## Change Order

**PROJECT:** (name and address)  
Walton County Public Safety Complex  
350 Georgia Ave  
Monroe, Georgia 30655

**CHANGE ORDER INFORMATION:**  
Change Order Number: 018  
Date: 05/02/2025

# PCCO #018

**1 JAIL SUPPORT HVAC PART PLAN - ZONE B**  
SCALE: 1/8" = 1'-0"  
1/4" = 1'-0"  
SCALE  
FEET

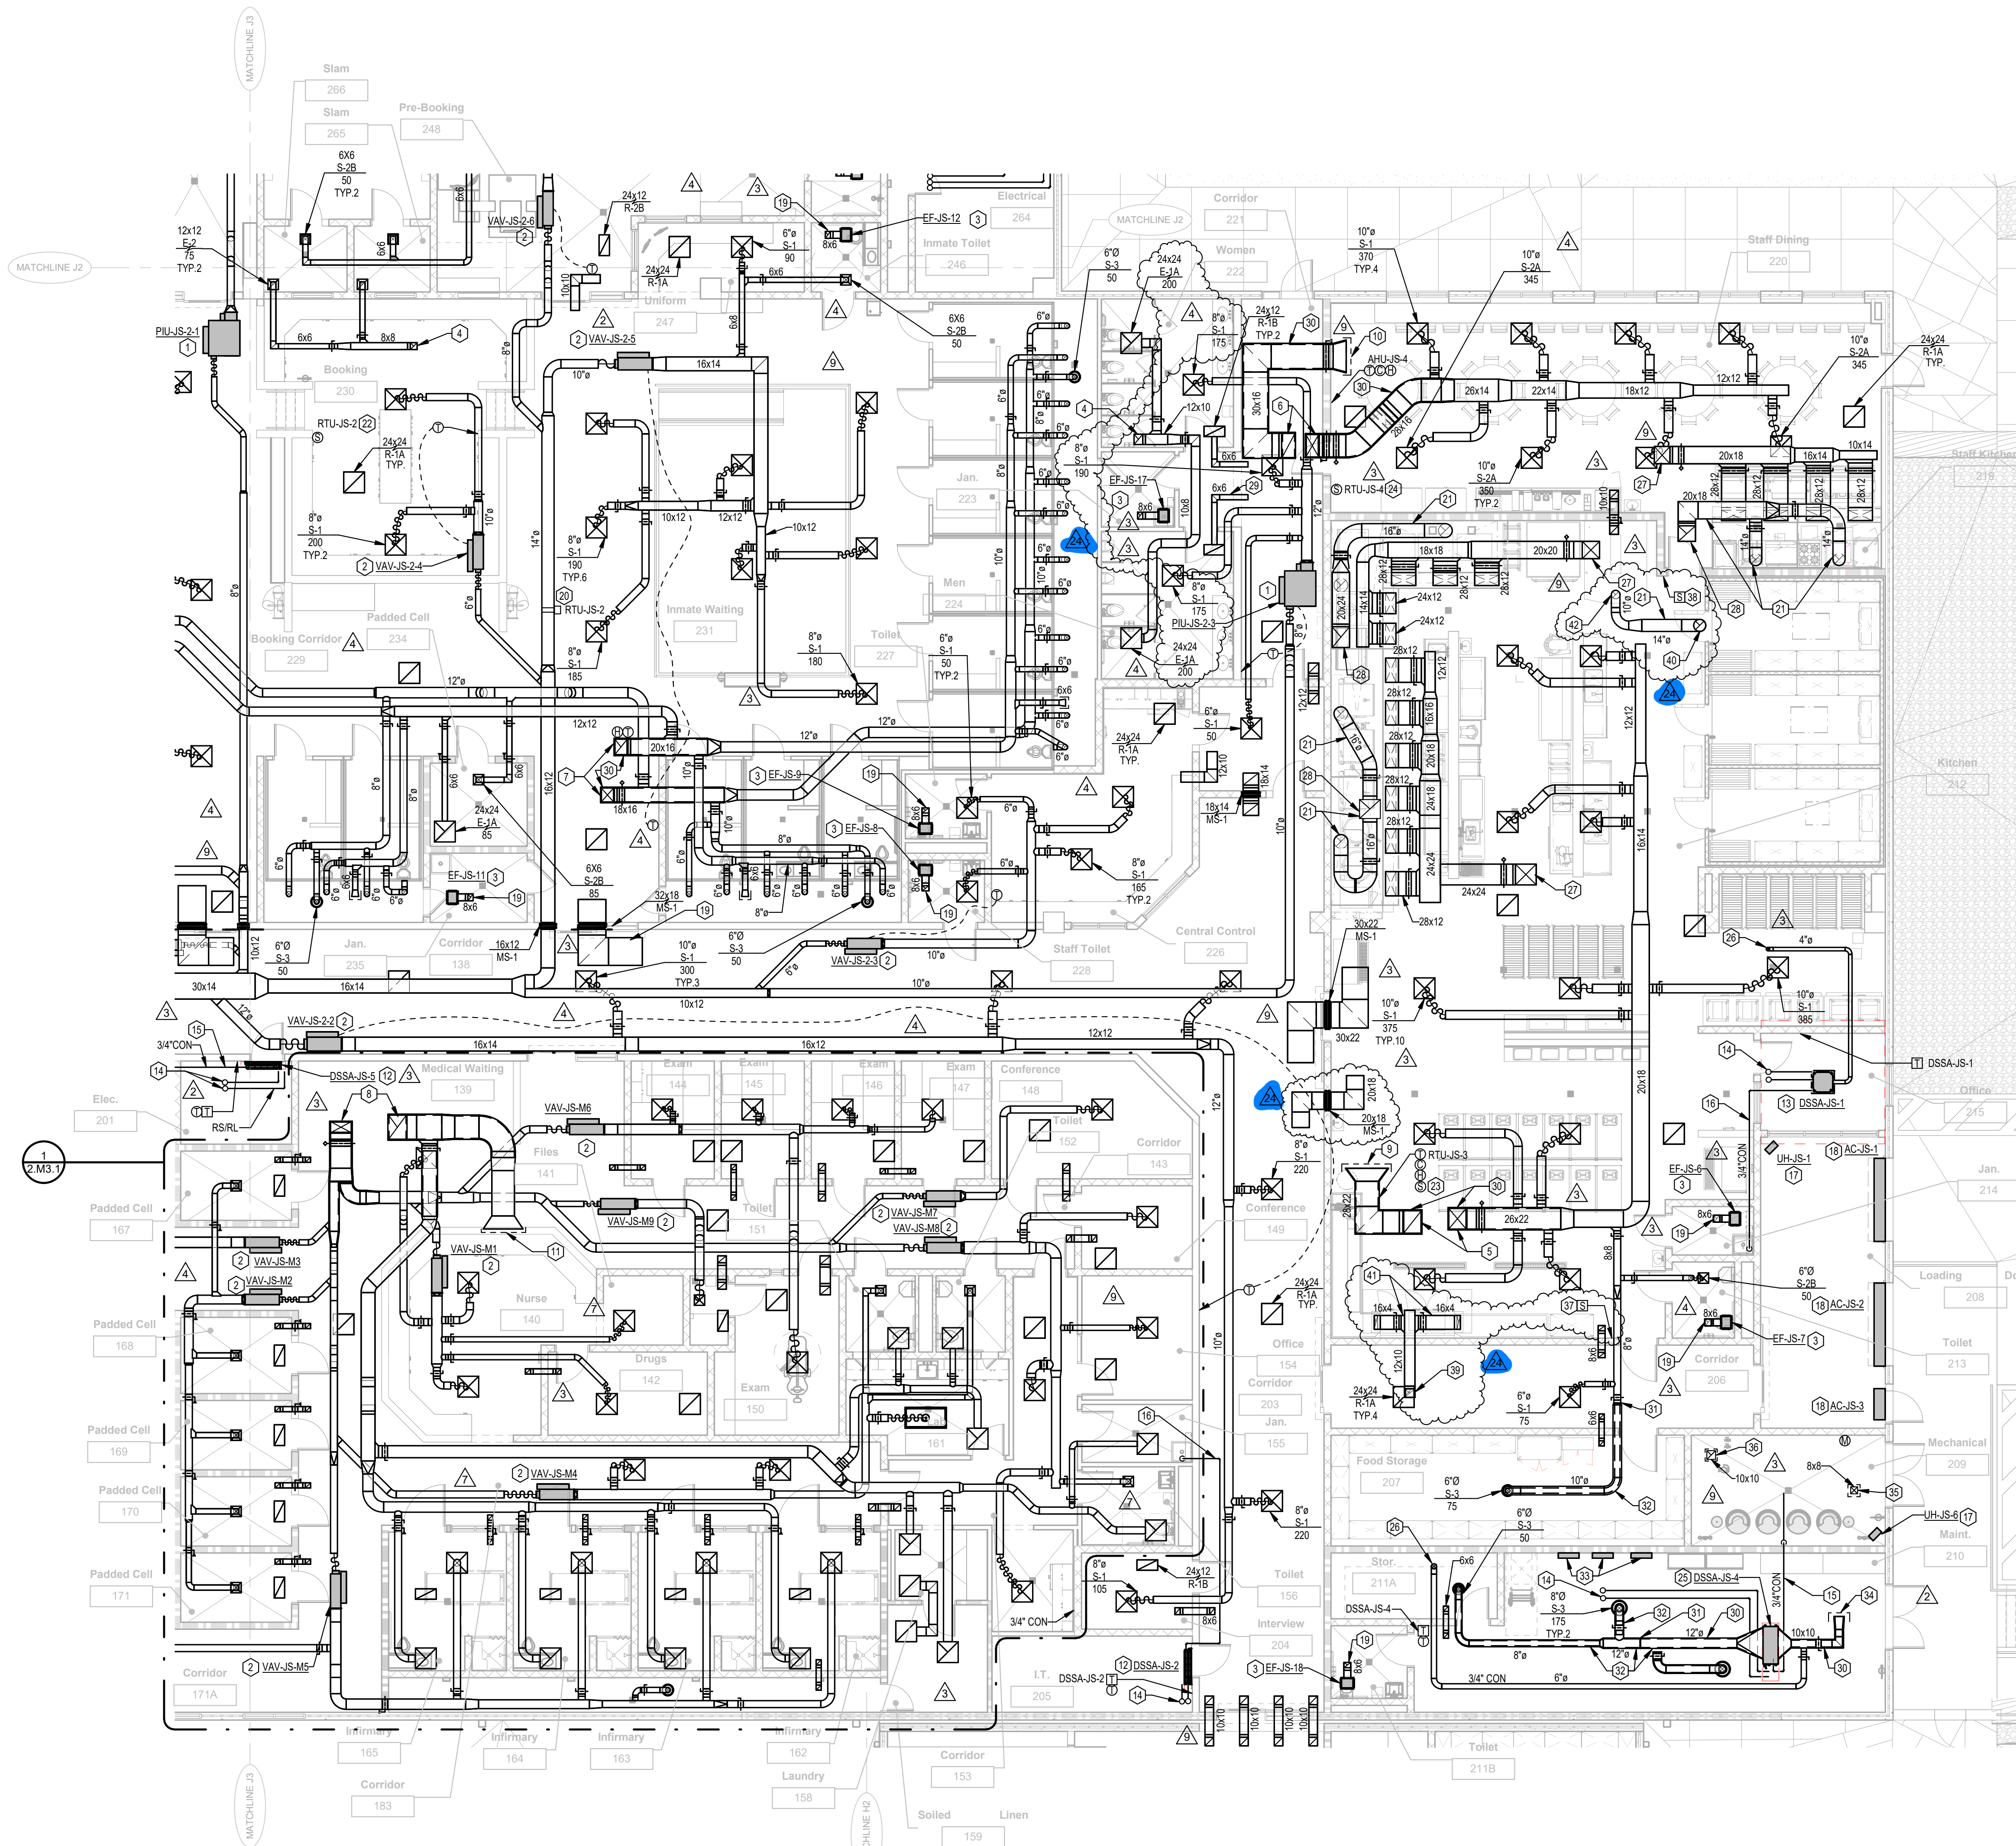
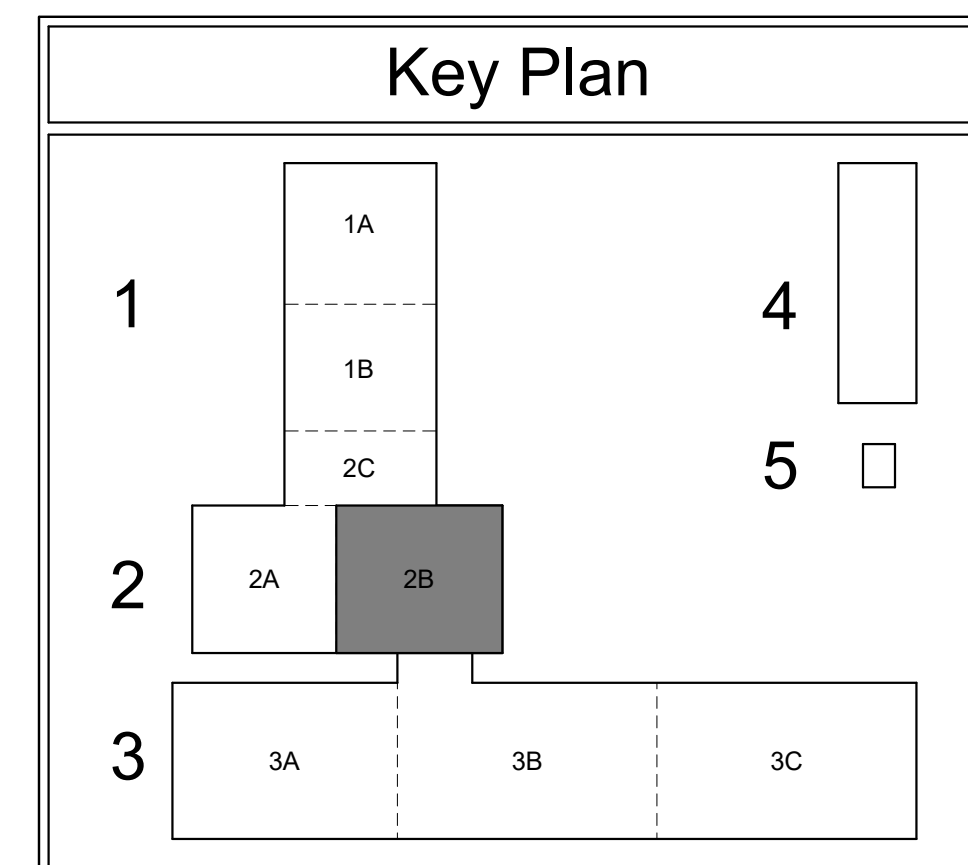
Item 51 on drawing 2.K1.2 (Hobart Conveyor Dishwasher) is shown to have two vent hoods that enter the ceiling and connect to the building's ductwork. Detail 3/2.K6.0 details how the exhaust duct should connect to the dryer and exit through the ceiling. Drawing 2.M2.2 does not show overhead ductwork connecting to the dishwasher. Please provide drawings for the overhead ductwork to connect to the dishwasher, an exit location for the exhaust, and please advise if an exhaust fan is needed.

Refer to attached revised sheets 2.M2.2, 2.M2.5, and 2.M5.1 and response from electrical engineer below.

**For the 1/6hp fan, I would feed from a 15A/1P in Panel LK and feed with 2#12,#12G in 0.75"C.**

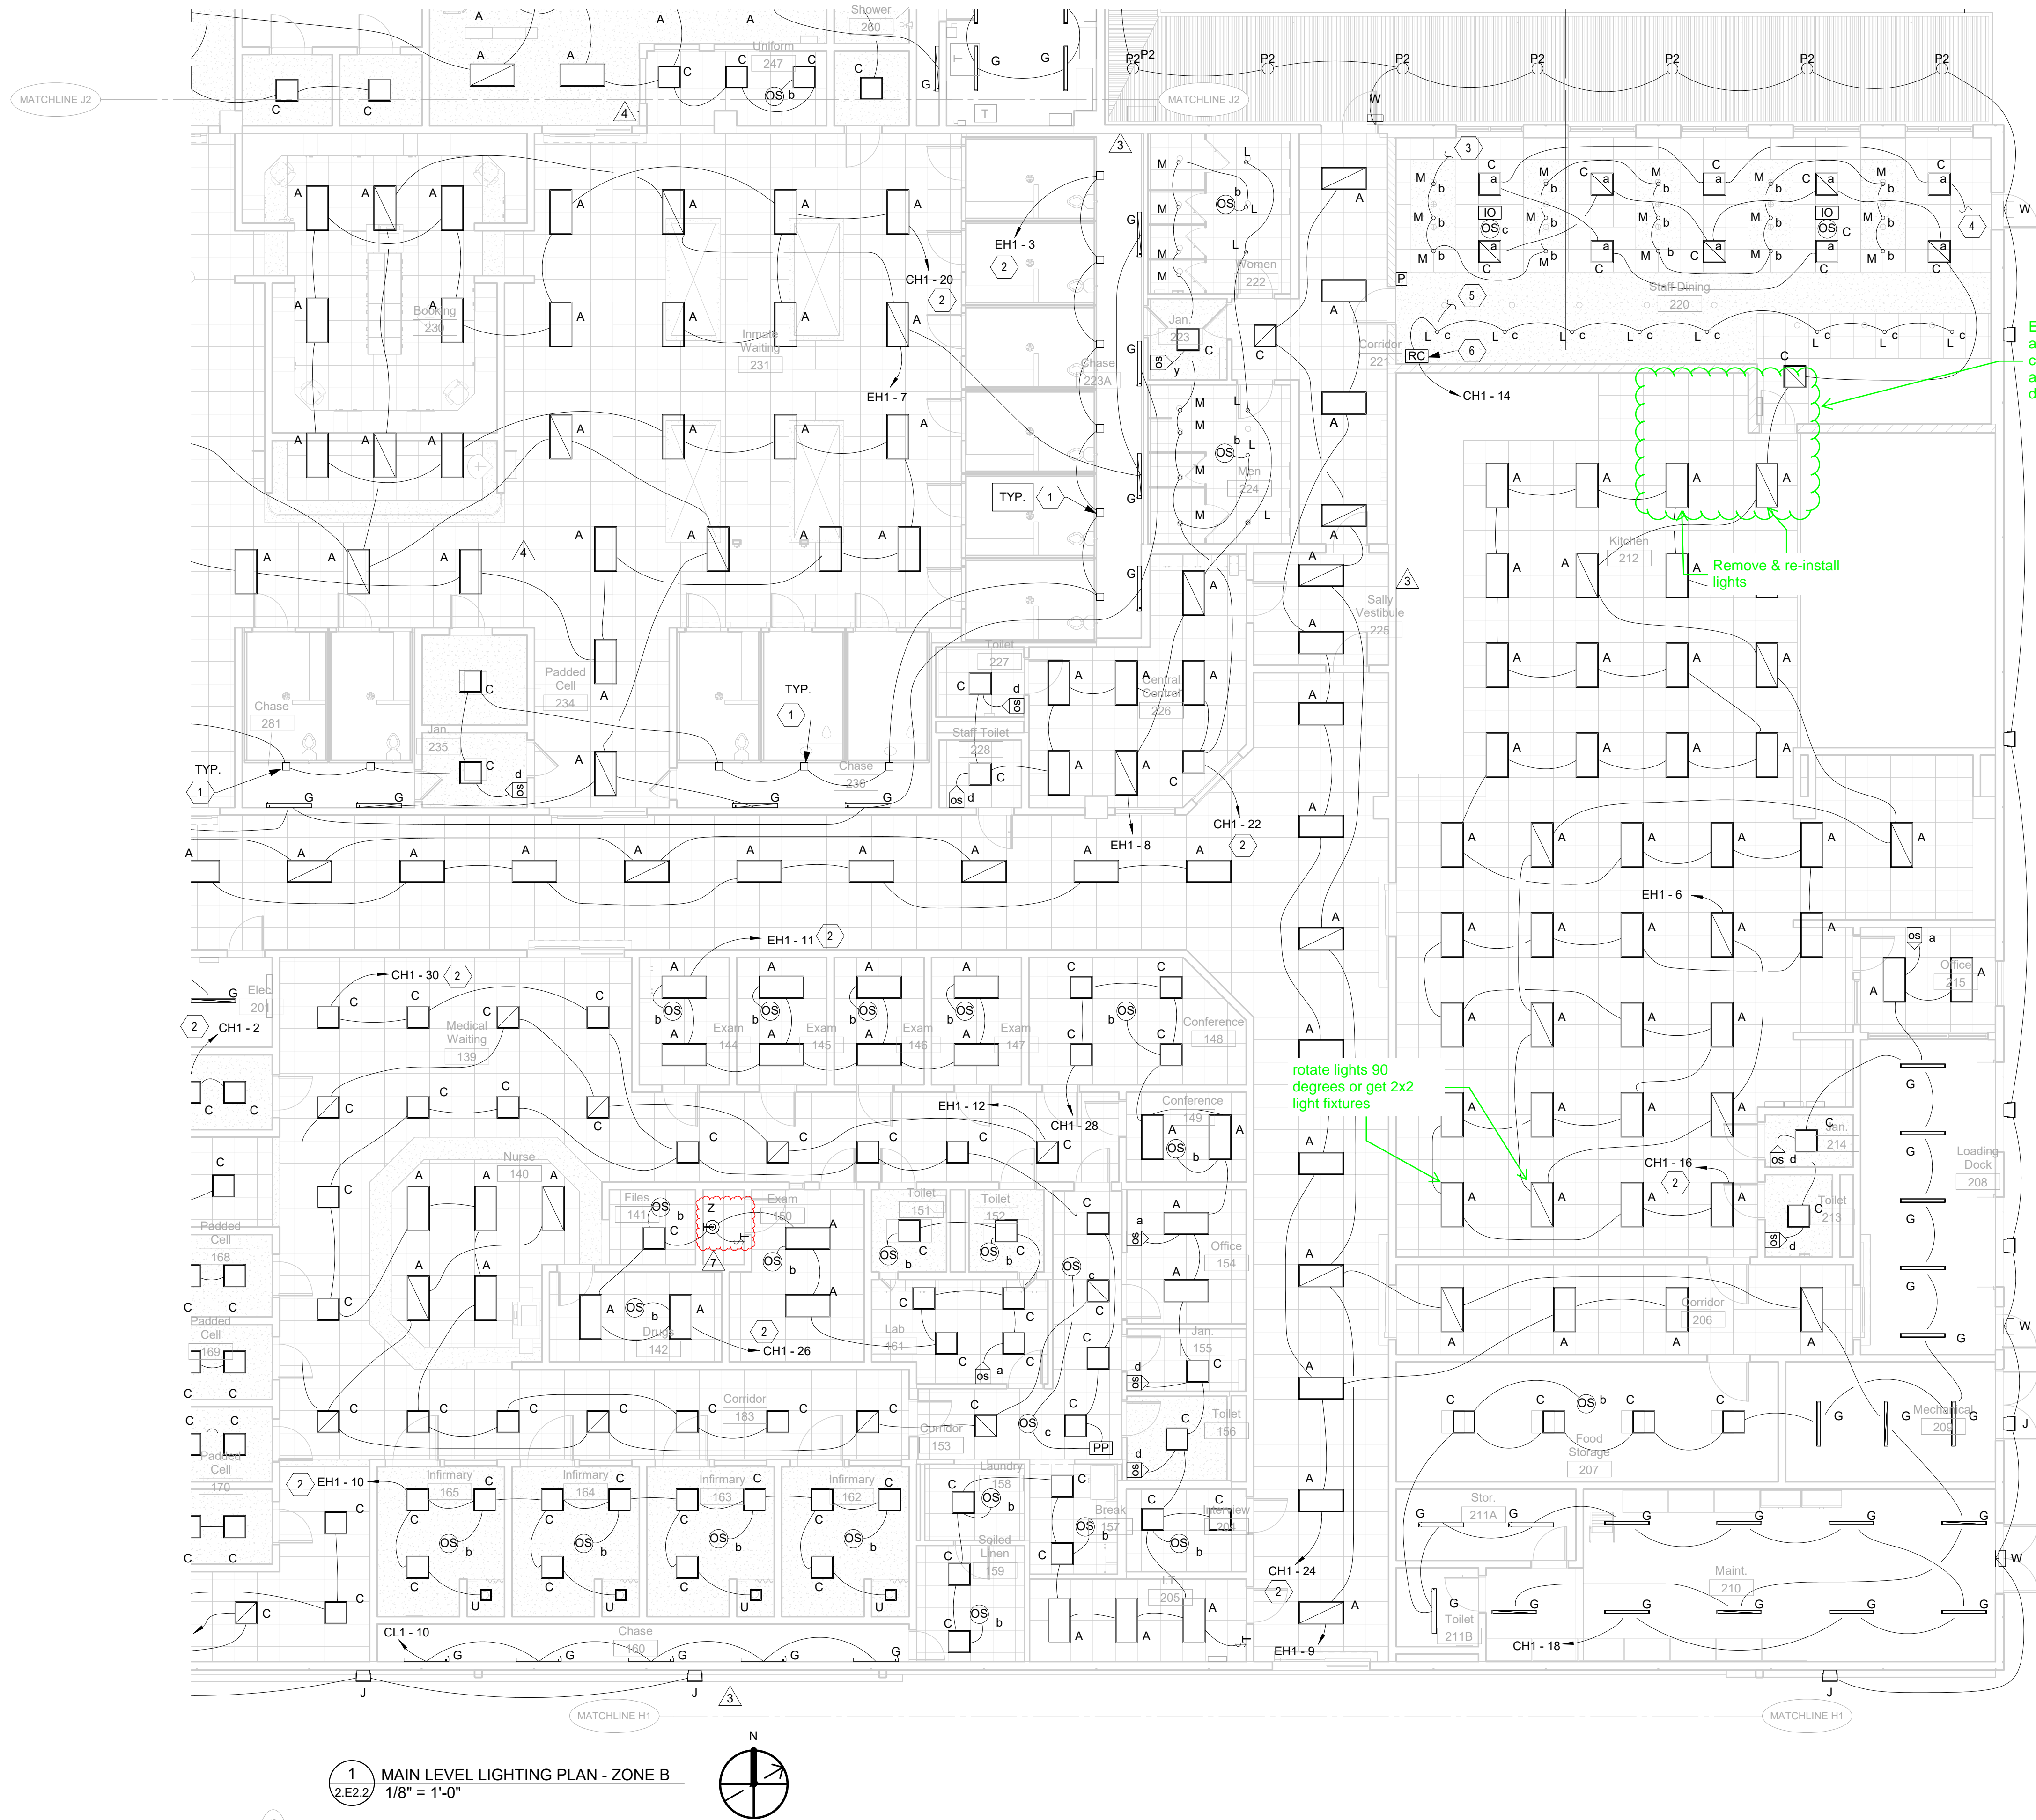
Remove and re-route plumbing highlighted.
